**KAWARTHA PINE RIDGE DISTRICT SCHOOL BOARD
PUR24-087-ITT
Clarke High School Classroom Refresh**

ADDENDUM NO. 2

**BARRY BRYAN
ASSOCIATES**

Project No.: 24035
Date: May 9, 2024
Tender No.: PUR24087-ITT
Project: **RECONFIGURATION CLASSROOMS AT CLARKE HIGH SCHOOL**
Kawartha Pine Ridge District School Board

5 RM 203
A701 1:50

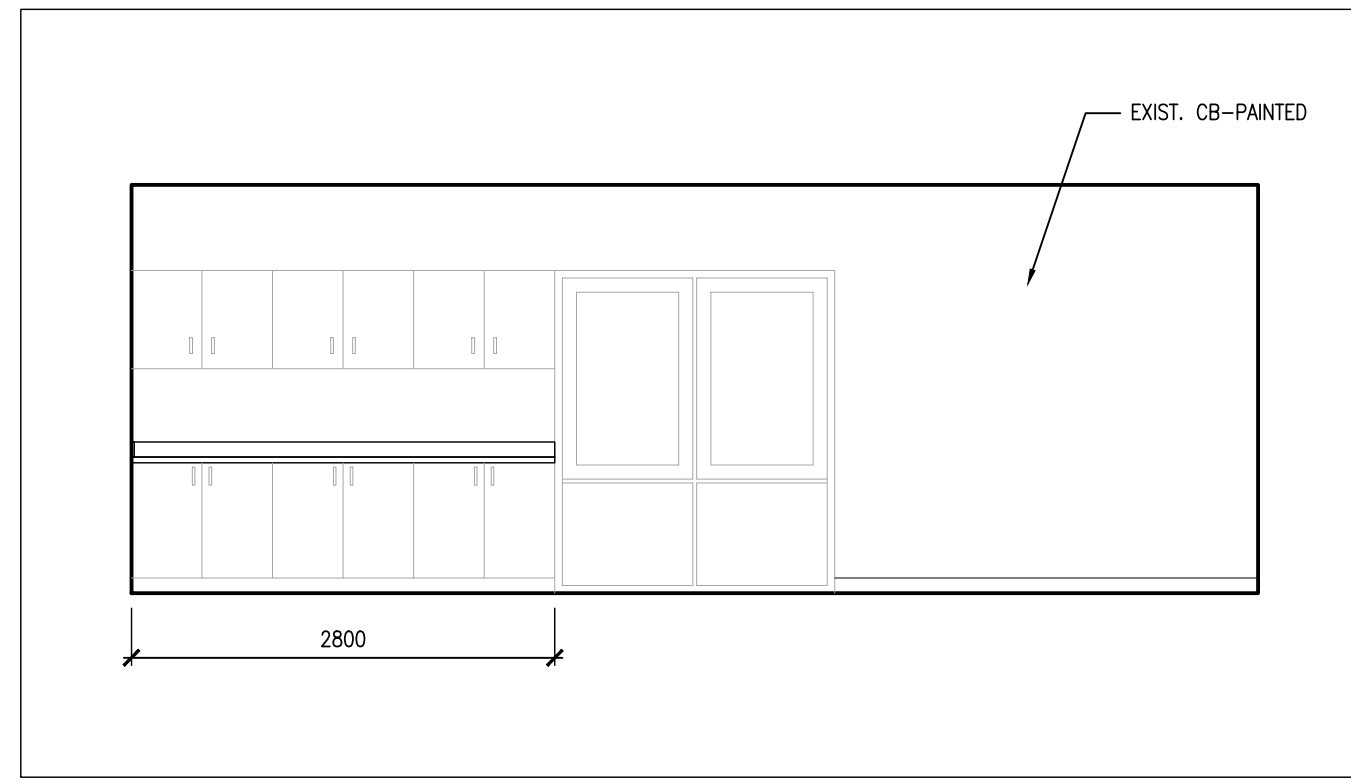
- .1 Revised door schedule: Fire resistant glazing "FRG" for Door 101.
- .2 Revised detail 5/A701.

DRAWING:
MILLWORK DETAILS

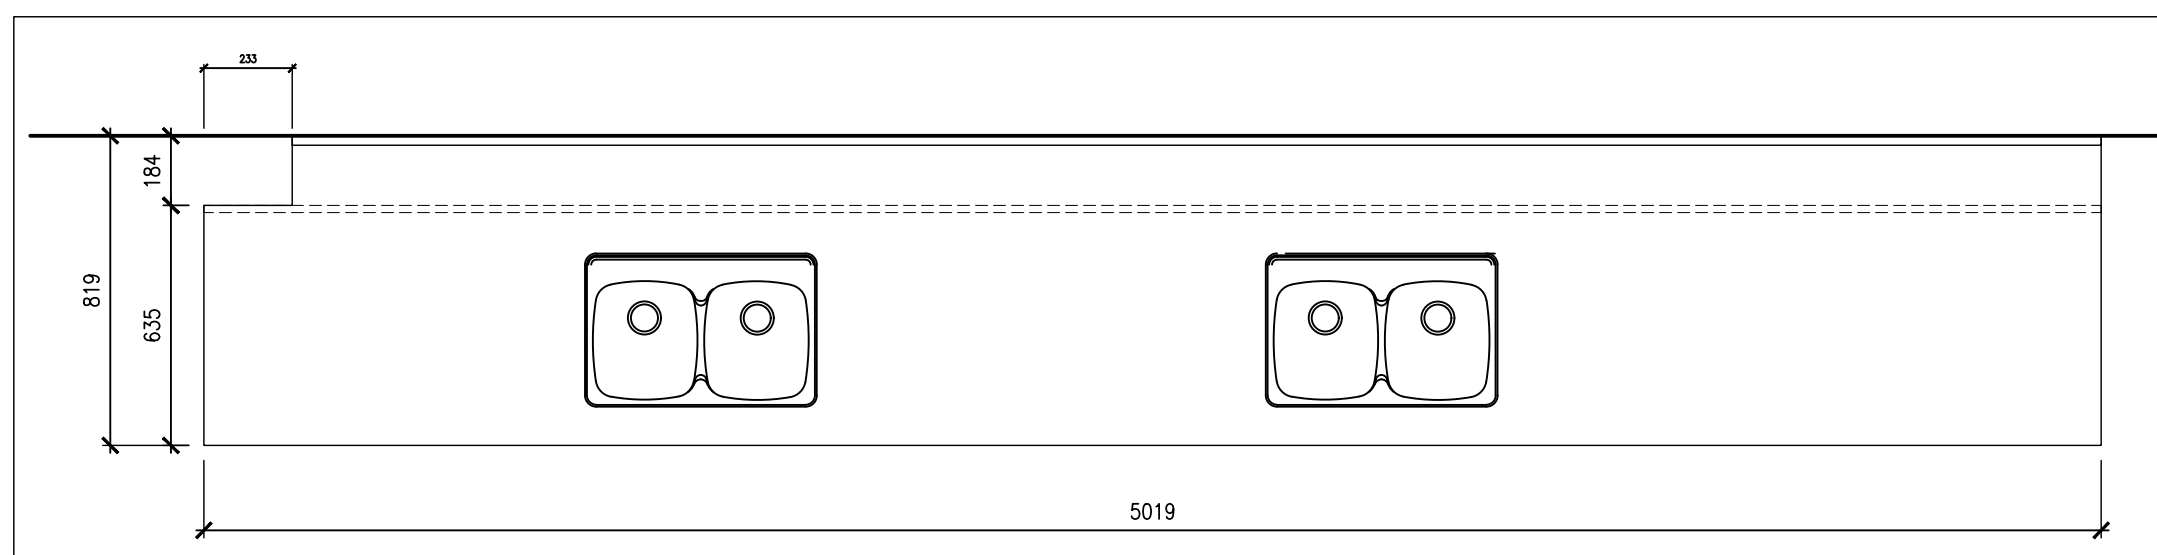
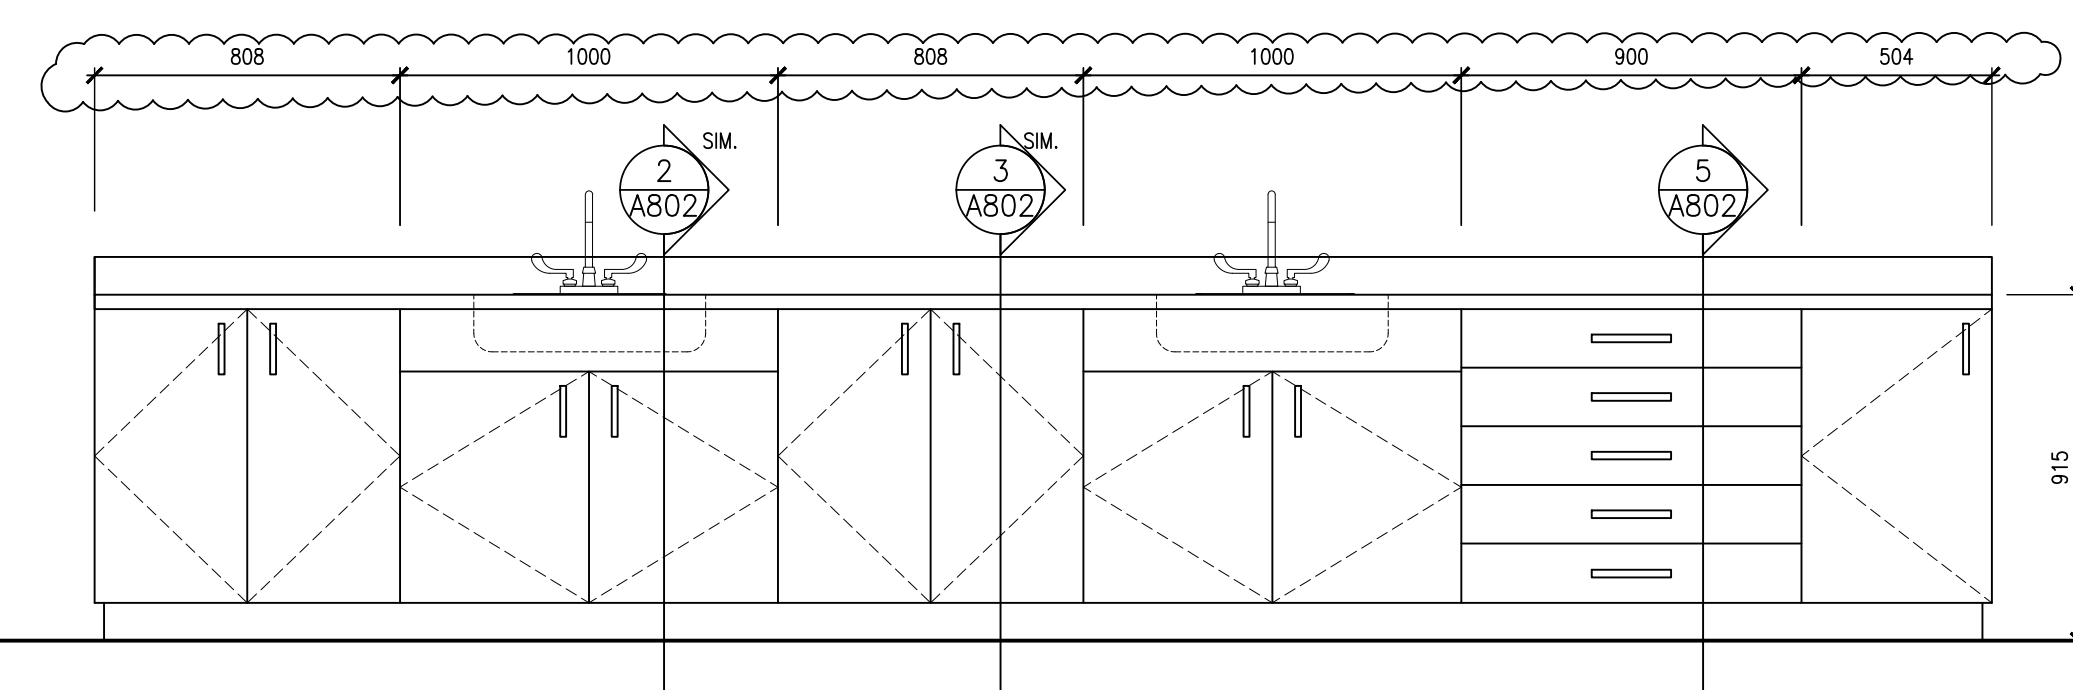
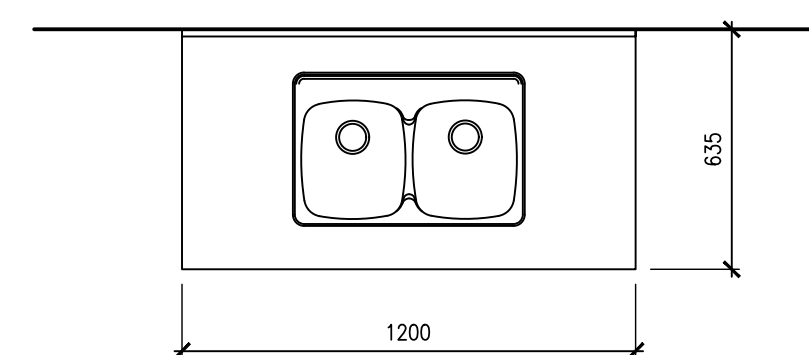
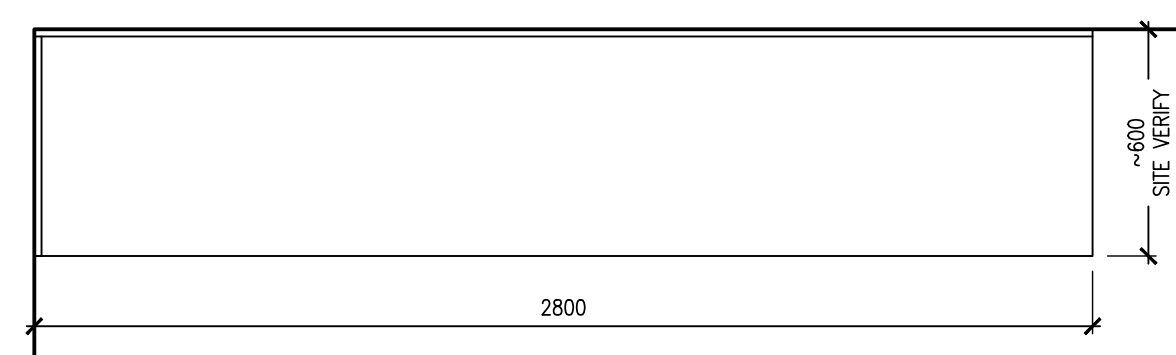
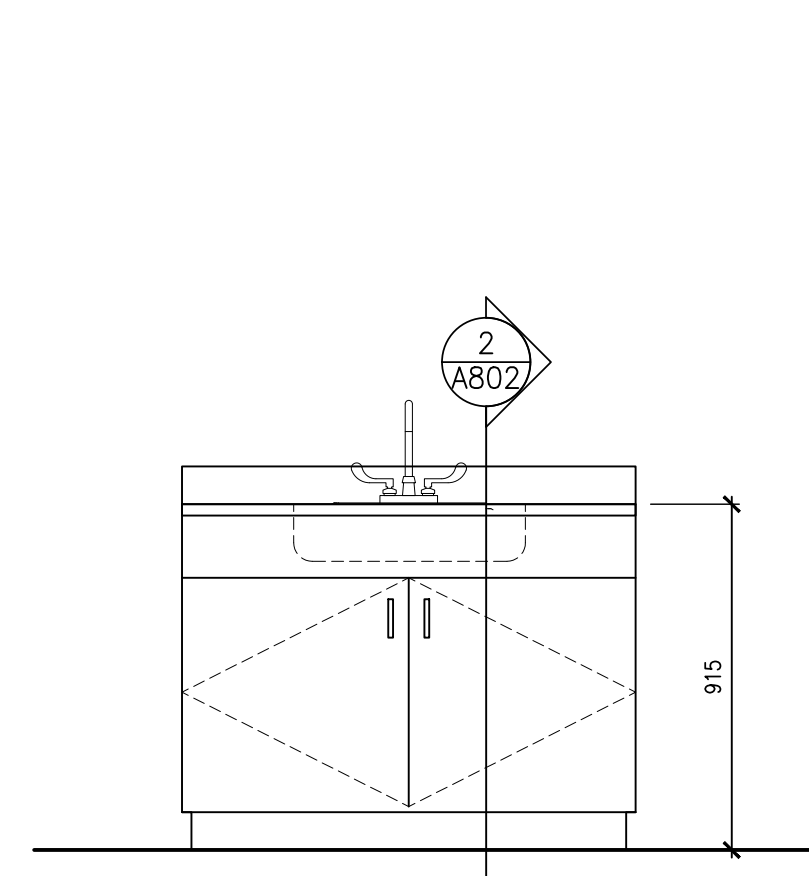
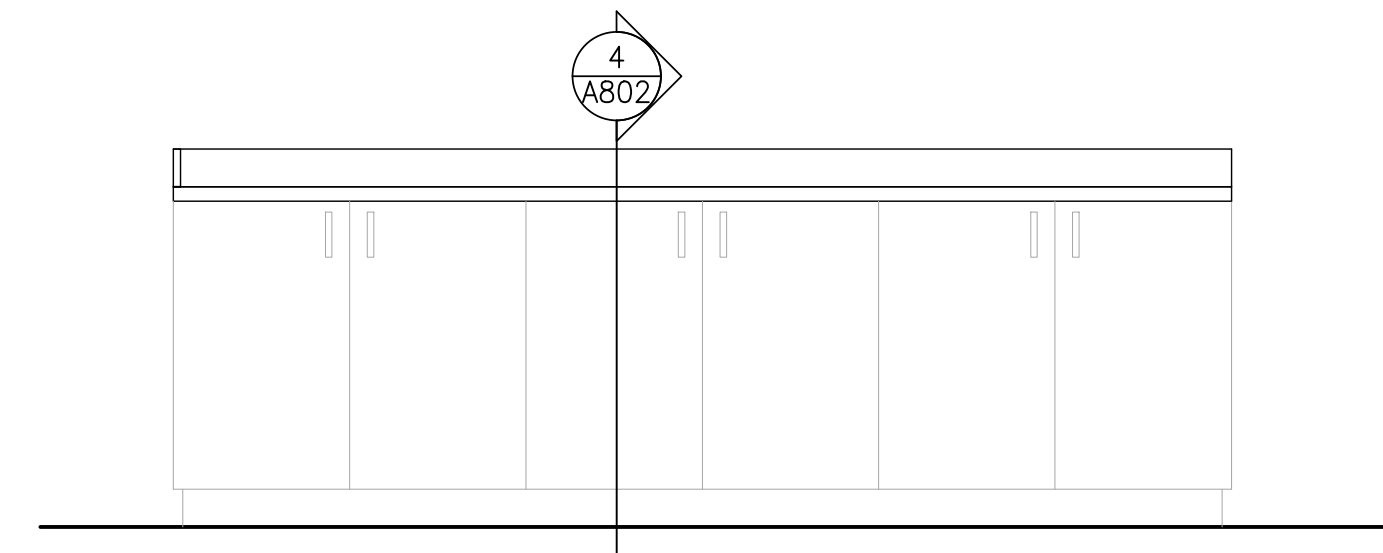
- .1 Additional dimensions.
